Proposal for 01 series of amendments to Regulation No. 129 (Enhanced Child Restraint Systems (ECRS))

Submitted by the Working Party on Passive Safety*

01 series of amendments to Regulation No. 129 (Enhanced Child Restraint Systems (ECRS))

Arrangements of the approval mark

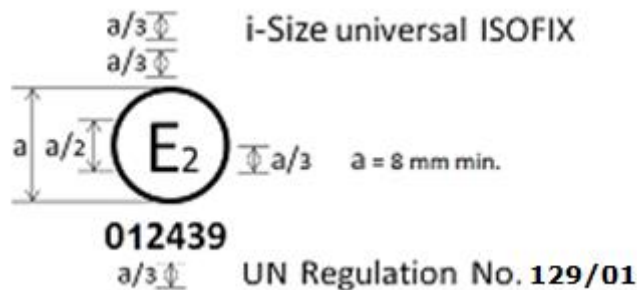
"Annex 2

The Enhanced Child Restraint System bearing the above approval mark is a device capable of being fitted in any i-size compatible vehicle seating position and of being used for the 40 cm - 70 cm size range and mass limit of 24 kg; it is approved in France (E 2) under the number 012439. The approval number indicates that the approval was granted in accordance with the requirements of the Regulation concerning the approval of Enhanced Child Restraint Systems used onboard of motor vehicles as amended by the 01 series of amendments. In addition the name of the regulation has to be identified on the approval mark followed by the series of amendment according to which the approval has been granted.

Arrangements of the approval mark in combination with a module mark

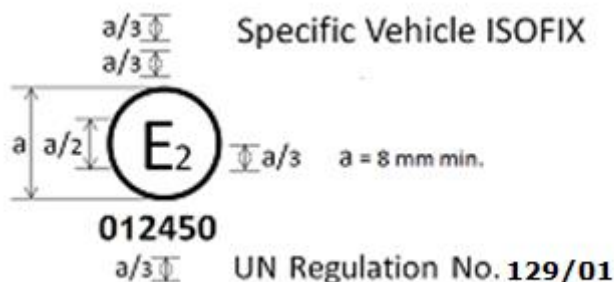
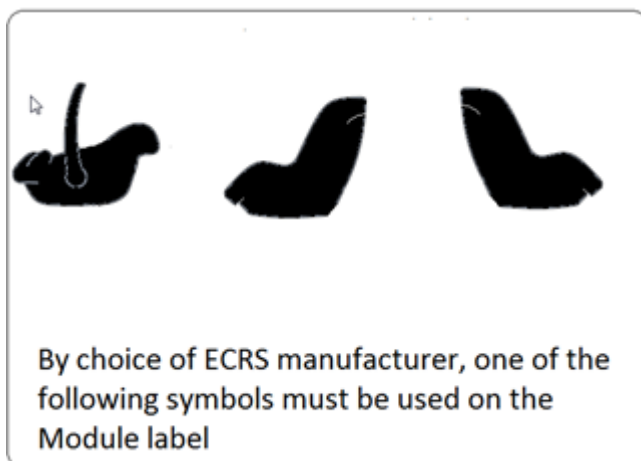
The Enhanced Child Restraint System bearing the above approval mark is a device, including module(s), capable of being fitted in any i-size compatible vehicle seating position. It is approved in France (E 2) under the number 012439. The approval number indicates that the approval was granted in accordance with the requirements of the Regulation concerning the approval of Enhanced Child Restraint Systems used on board of motor vehicles as amended by the 01 series of amendments. In addition the name of the regulation has to be identified on the approval mark followed by the series of amendment according to which the approval has been granted.

The Enhanced Child Restraint System module bearing the above module mark capable of being used for the 40 cm - 70 cm size range and mass limit of 24 kg; it is approved under the number 012439 to be used in combination with device approved according to Regulation No. 129 under the same number 012439. The approval number indicates that the approval was granted in accordance with the requirements of the Regulation concerning the approval of Enhanced Child Restraint Systems used on board of motor vehicles as amended by the 01 series of amendments."

Figure 1
Dimensions in mm of the seat and the seat cushions

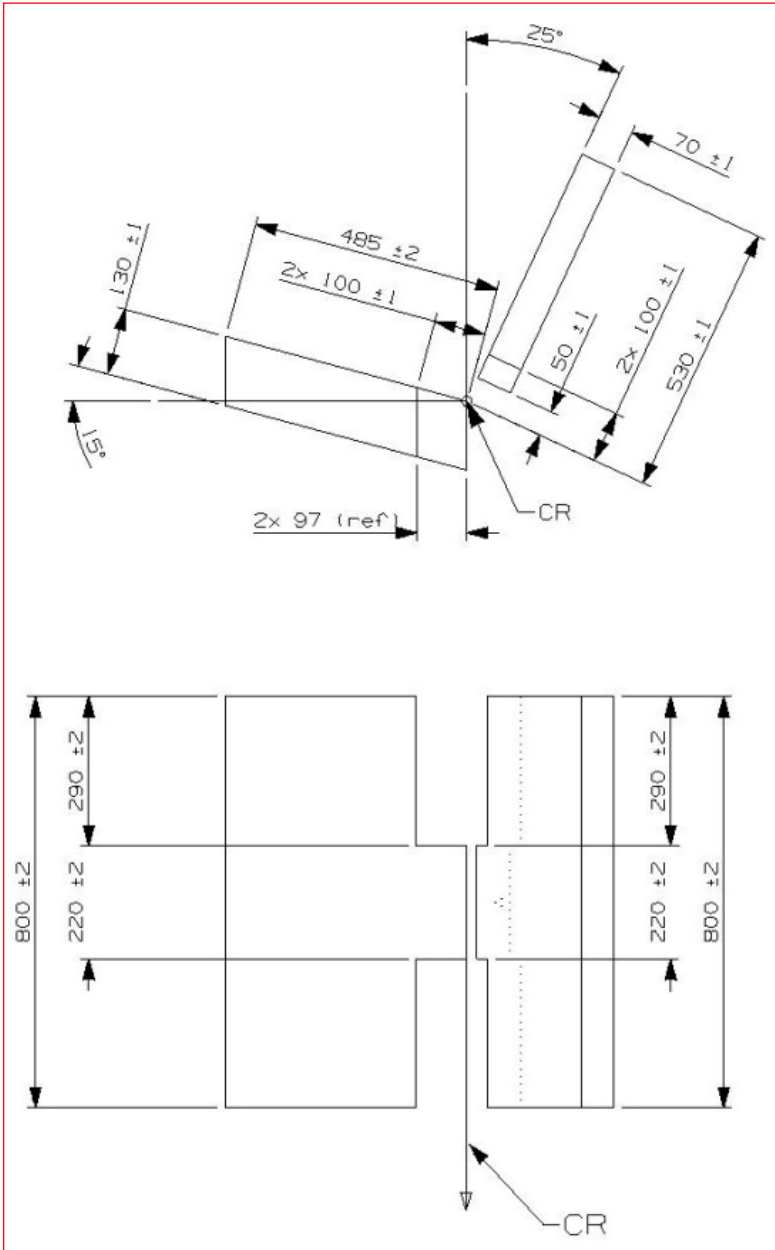
"Annex 6 - Appendix 1

Top View – Bench with ISOFIX anchorages (Tolerance general: ± 2 mm)

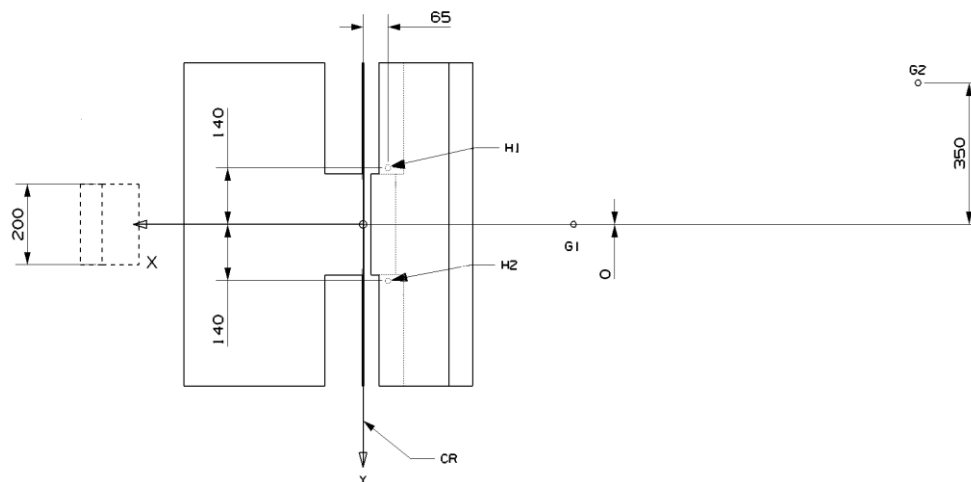
1. The anchorages shall be positioned as shown in the figure below.
2. Enhanced Child Restraint Systems in the i-Size universal, specific and restricted categories shall use the following anchorage points: H1 and H2.

Figure 1
Door panel geometry and position at T0 – Top view

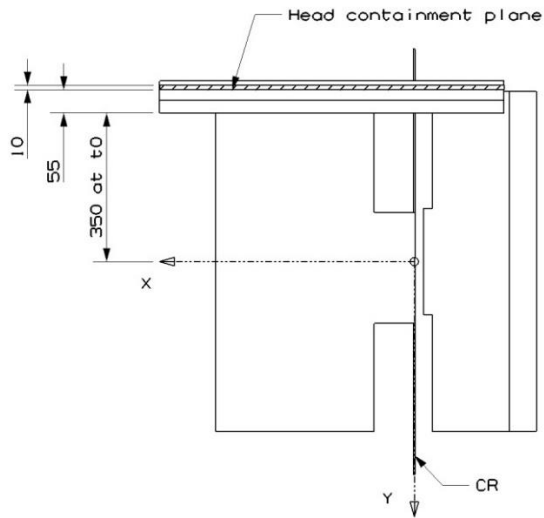
Appendix 3, amend to read:

Figure 4
Corridor for the padding material

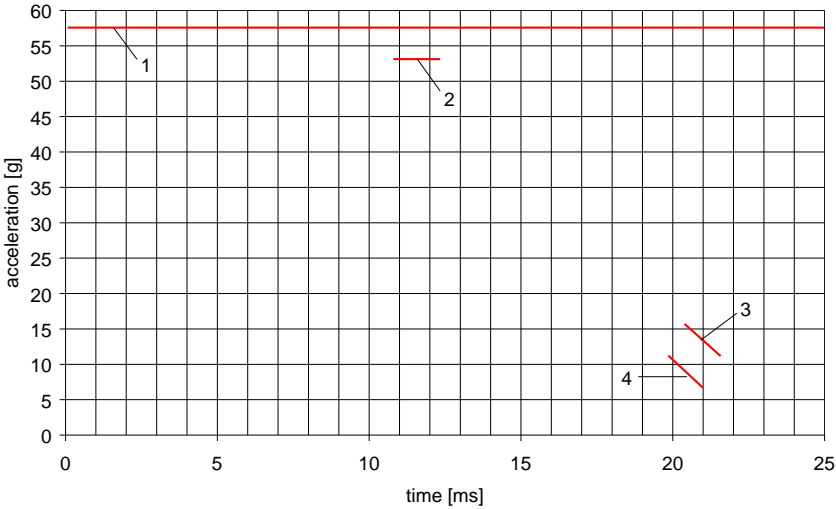
The impactor acceleration shall not exceed 58 g.

Figure 2
Side and Front View of the measuring device

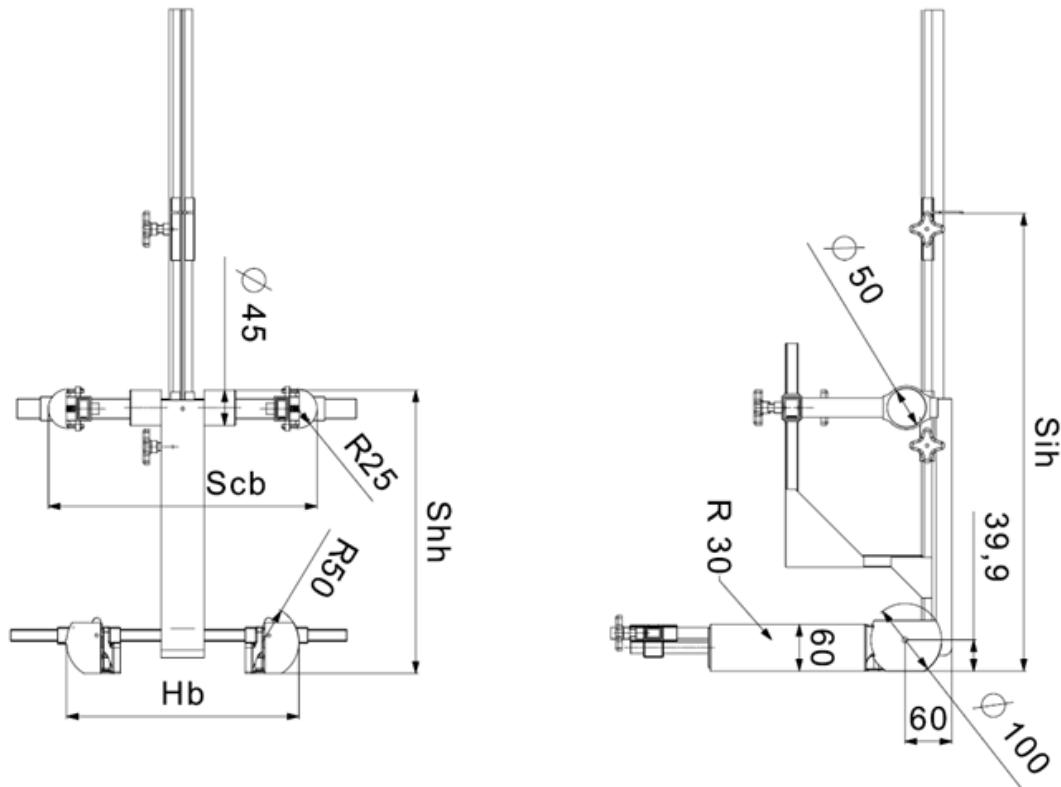
Annex 18, amend to read:
